NEW ELEMENTARY AND MIDDLE SCHOOL

CONTENTS - VOLUME TWO

phase	Bid Package No. 2
date	January 3, 2008
ADD	October 17, 2007
ADD	October 26, 2007
ADD	November 2, 2007
ADD	November 5, 2007

project # 06022

project# | 06022
Lighting Plan
Sector "E"

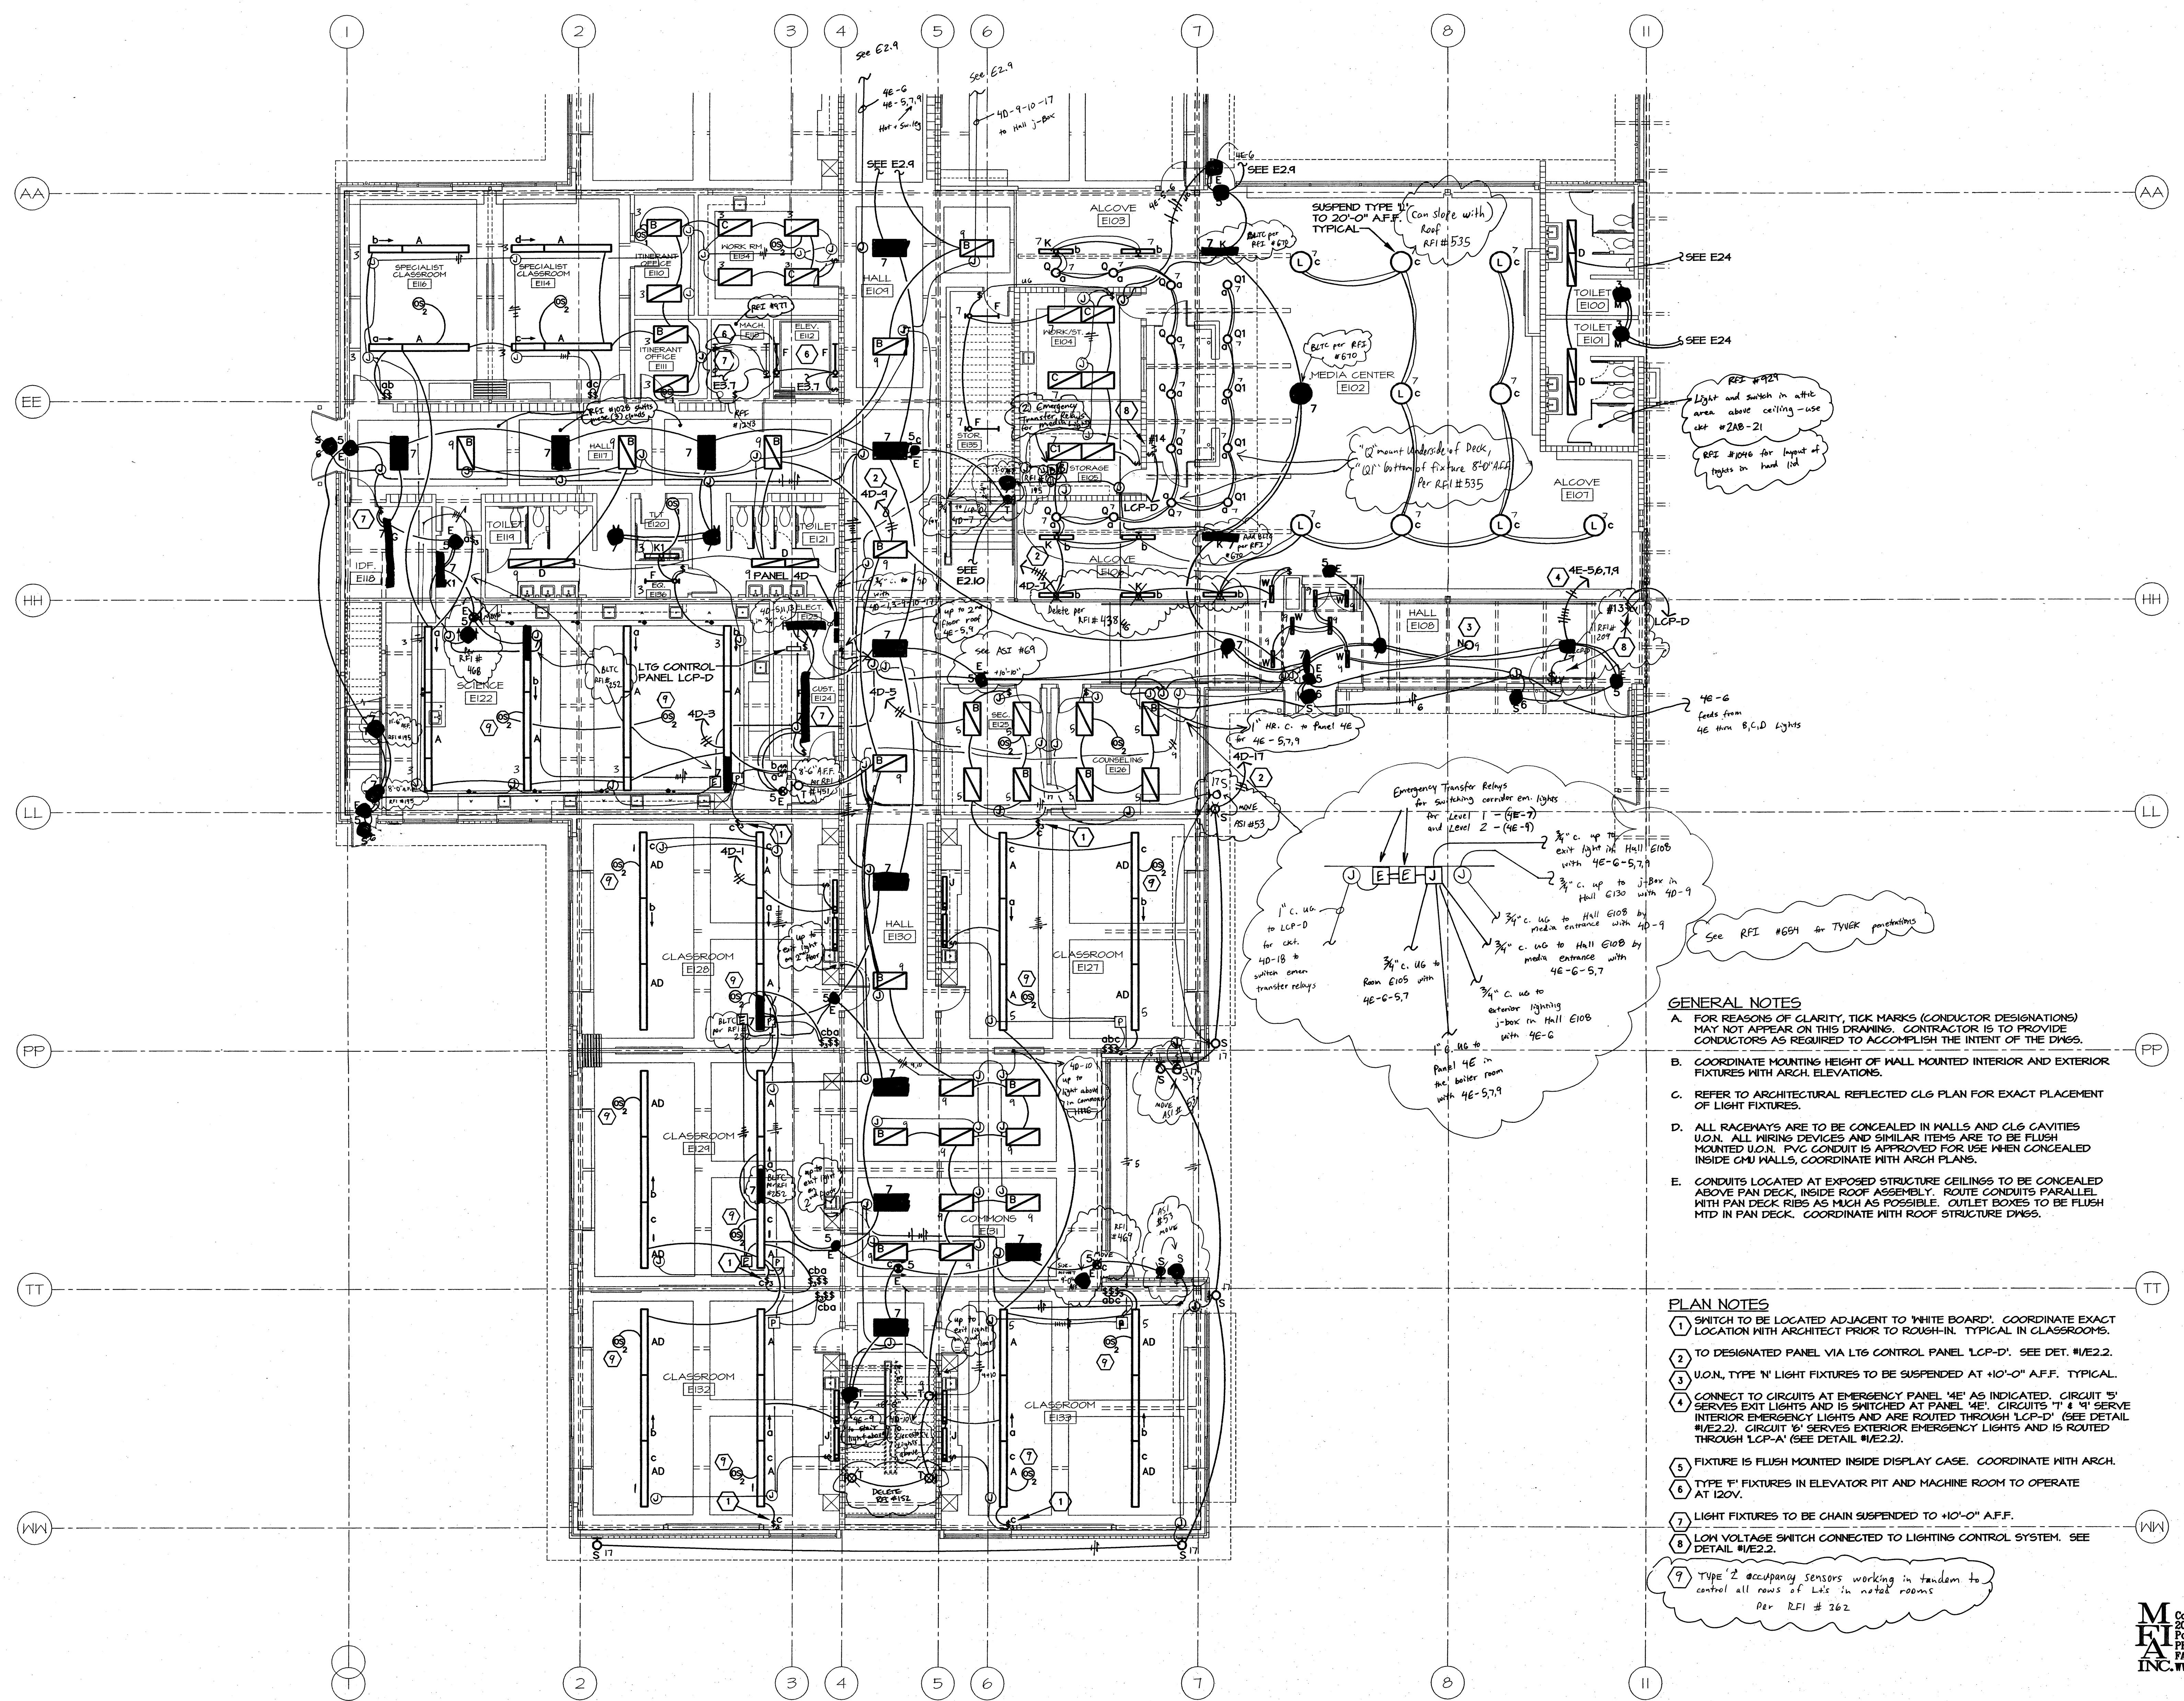
9) TYPE '2' occupancy sensors working in tandem to control all rows of L's in notebook rooms
Per RFI # 362

E2.8 LIGHTING PLAN - SECTOR "F"
SCALE: 1/8" = 1'-0"

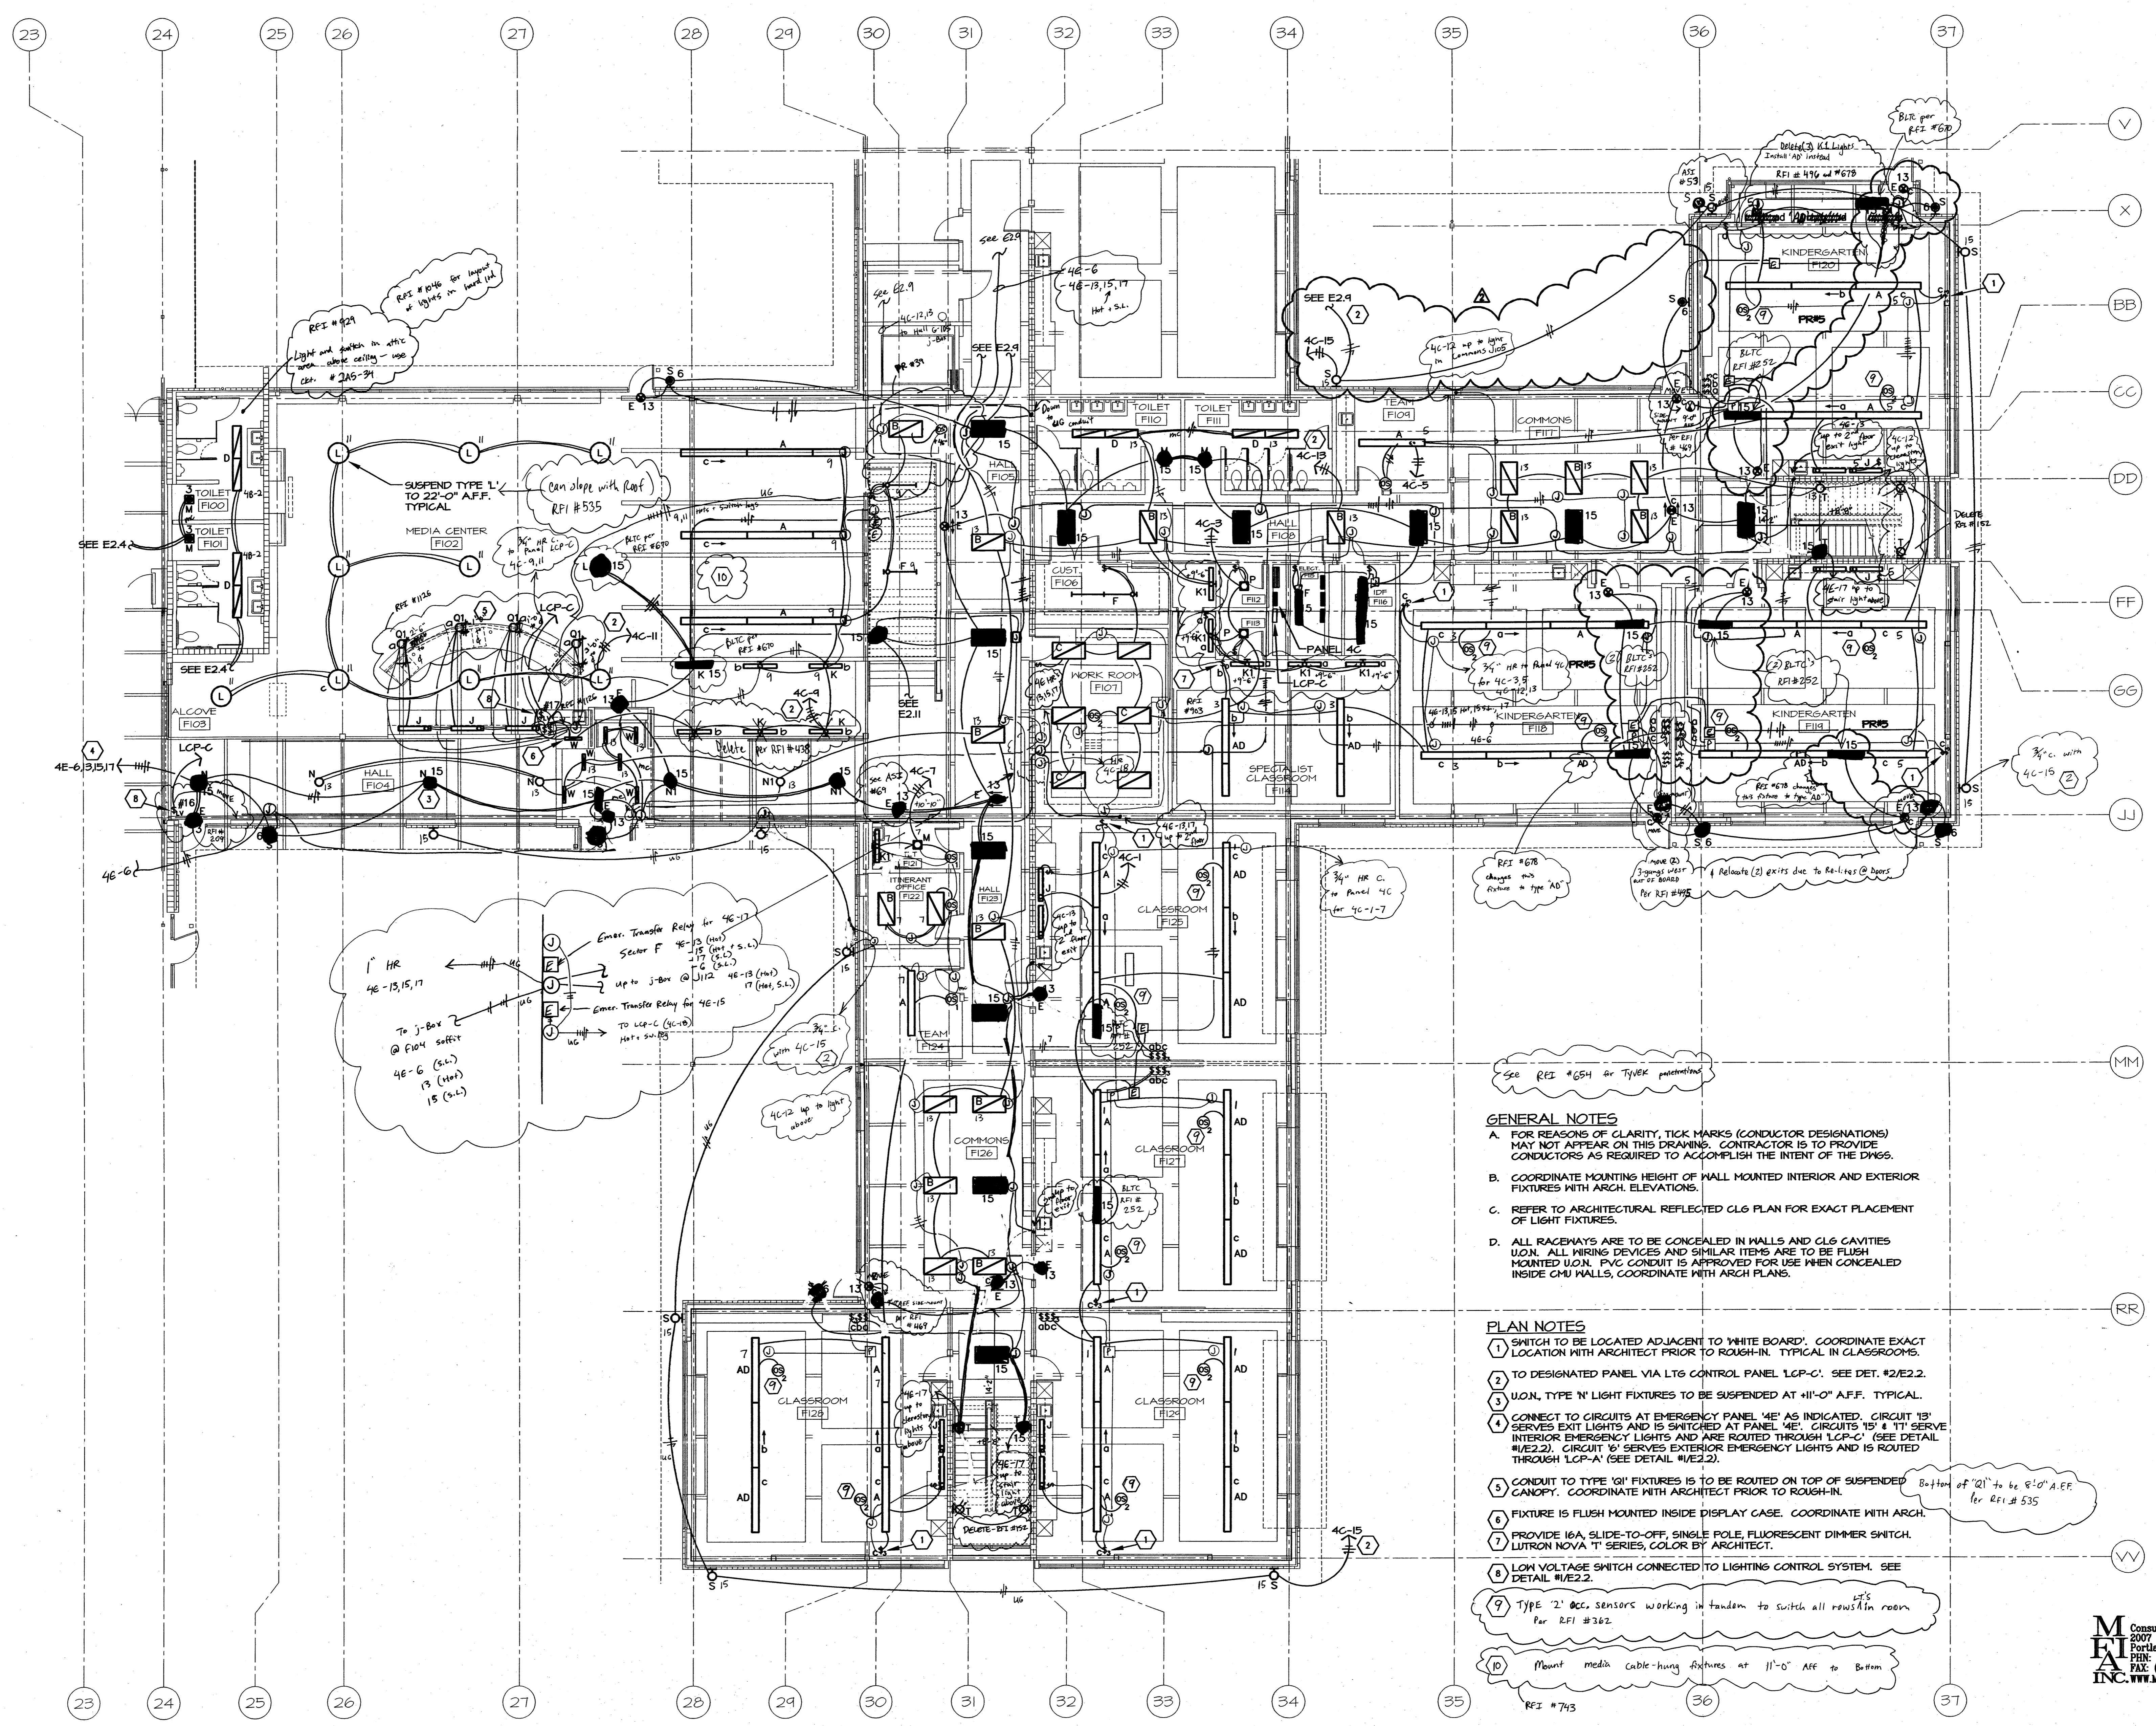
- TYPE '2' OCC. SENSORS WORKING IN TANDEM TO SWITCH ALL rooms in room. Per RFI #362.
 - Mount media cable-hung fixtures at 11'-0" AFF to bottom. RFI #793.
